REVISIONS - 10/04/2024
- LAKE PARK MARINA WATERFRONT DISTRICT SIGNAGE ADDED ON NORTH AND SOUTH INTERSECTIONS OF BROADWAY.
- WEST SIDE OF BAYBERRY DR UPDATED TO MATCH CIVIL.

NAUTILUS 220
Lake Park, Florida

SITE PLAN

DETAILS
PLAN

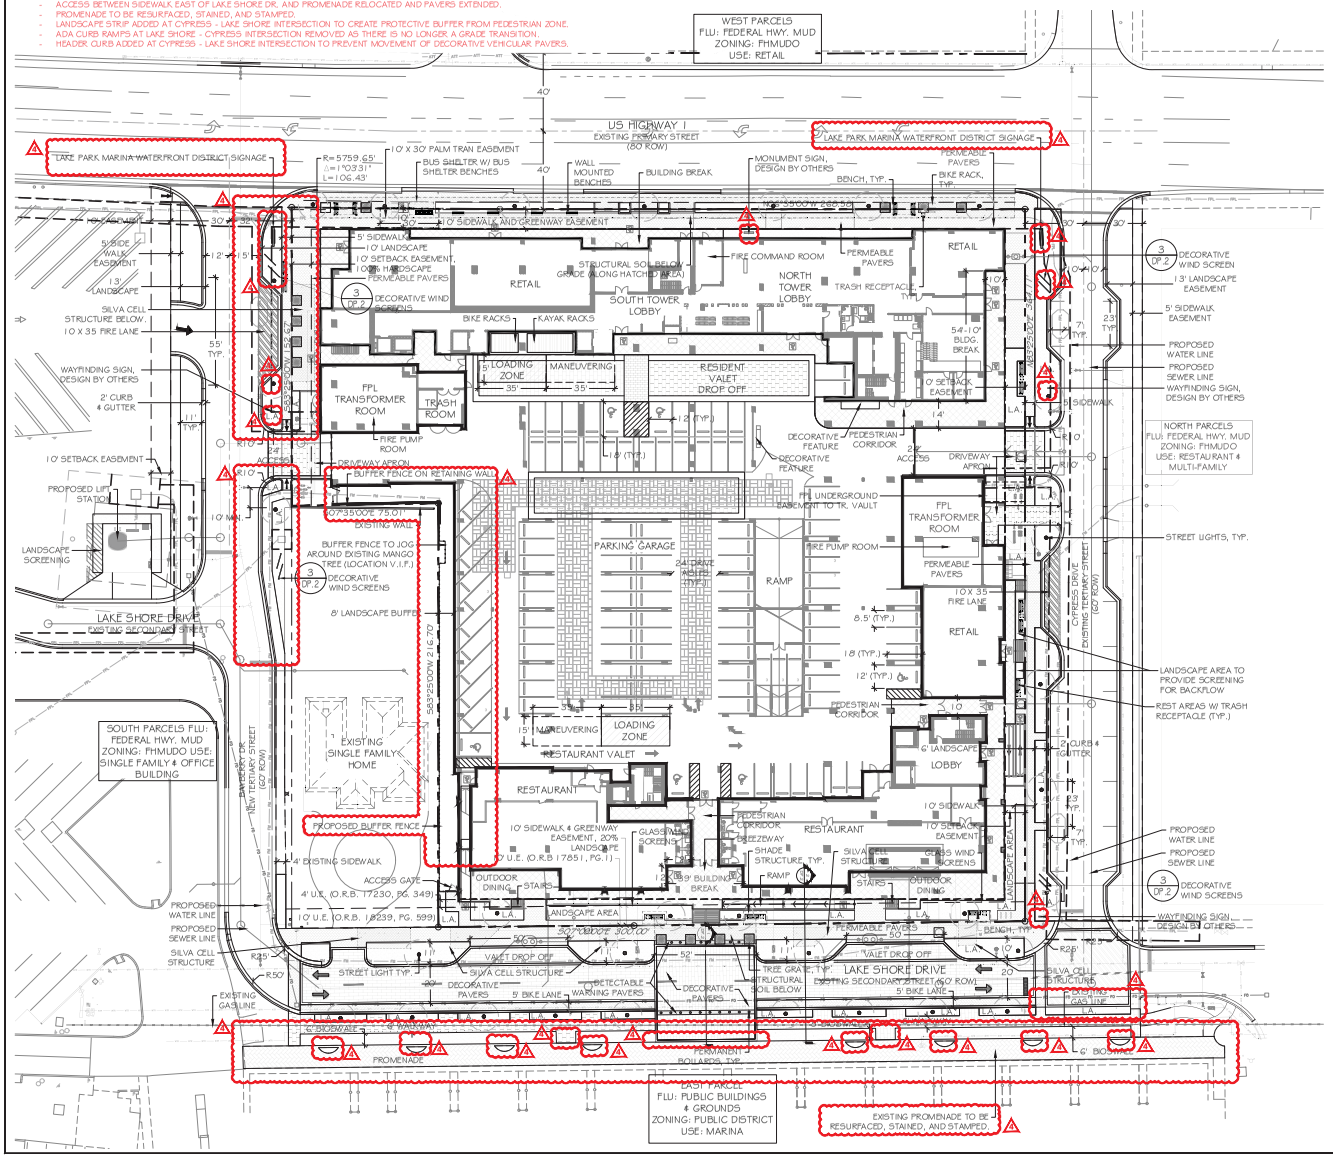
- WIND SCREENS LOCATIONS ON BAYBERRY DR UPDATED TO AVOID CONFLICTS WITH SHIFTING CURB LINES.
- LIGHT POLE LOCATIONS ON WEST OF BAYBERRY DR UPDATED TO AVOID CONFLICT WITH SHIFTING CURB LINES.

- GRADE TRANSITION AT PROMENADE ALONG LAKE SHORE HAS BEEN REVISED AS PER UPDATED CIVIL ENGINEERING UPDATES.
- RESIDENTIAL BUFFER UPDATED TO SHOW RETAINING WALL ALONG THE PROPERTY LINE WITH A 6' BUFFER FENCE MOUNTED ATOP THE WALL.

- NAUTILUS MONUMENT SIGN ADDED ON BROADWAY.
- NAUTILUS WAYFINDING SIGNS ADDED ON CYPRESS AND BAYBERRY.
- PLANTER WALLS AT BIOSWALE REMOVED AS THEY ARE NOT REQUIRED.

- 8 EXISTING ROYAL PALMS AND PLANTING AREAS ON PROMENADE WALL BE PRESERVED.
- ACCESS BETWEEN SIDEWALK EAST OF LAKE SHORE DR. AND PROMENADE RELOCATED AND PAVERS EXTENDED.

- PROMENADE TO BE RESURFACED, STAINED, AND STAMPED.
- LANDSCAPE STRIP ADDED AT CYPRESS - LAKE SHORE INTERSECTION TO CREATE PROTECTIVE BUFFER FROM PEDESTRIAN ZONE.

- ADA CURB RAMPS AT LAKE SHORE - CYPRESS INTERSECTION REMOVED AS THERE IS NO LONGER A GRADE TRANSITION.
- HEADER CURB ADDED AT CYPRESS - LAKE SHORE INTERSECTION TO PREVENT MOVEMENT OF DECORATIVE VEHICULAR PAVERS.

E LAKE PARK MARINA WATERFRONT DISTRICT SIGNAGE
SCALE = N.T.S.

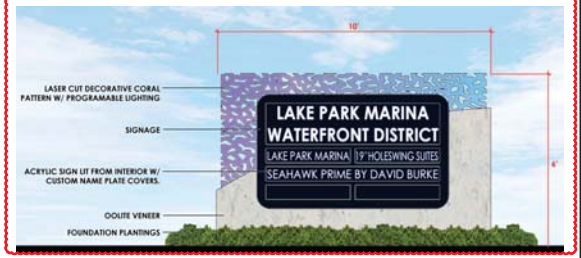
REVISIONS - 10/04/2024
- LAKE PARK MARINA WATERFRONT DISTRICT SIGNAGE DESIGN REVISED.
- BUS SHELTER AND SHADE STRUCTURE RE-SPECIFIED DO TO ORIGINAL PRODUCT BEING DISCONTINUED.
- GROUND LEVEL PAVERS COLORS UPDATED.
- DECORATIVE SCREEN DESIGN REVISED.
- WAYFINDING SIGN DESIGN REVISED.
- MONUMENT SIGN DESIGN REVISED.

1 LAKE SHORE DRIVE SECTION

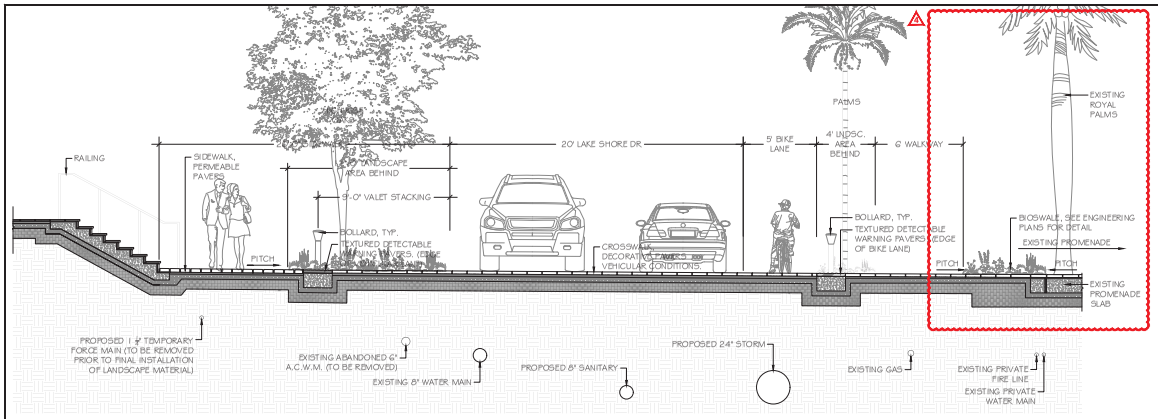
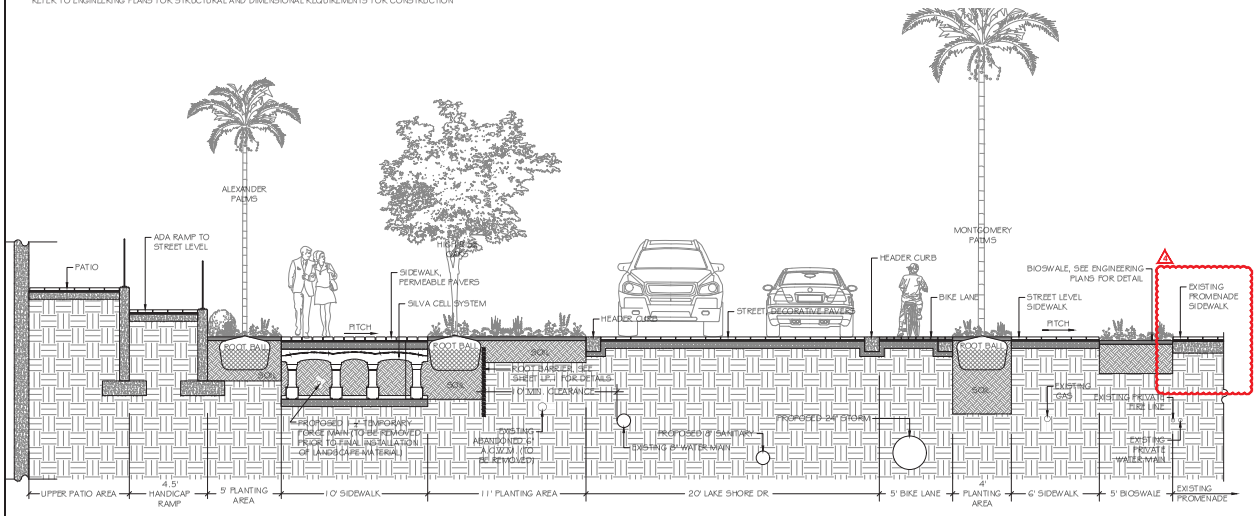
1 REVISIONS - 10/04/2024
- LAKE SHORE SECTIONS UPDATED TO SHOW FINAL TOPOGRAPHIC TRANSITIONS AT PROMENADE.
- DECORATIVE WIND SCREEN DESIGN UPDATED.
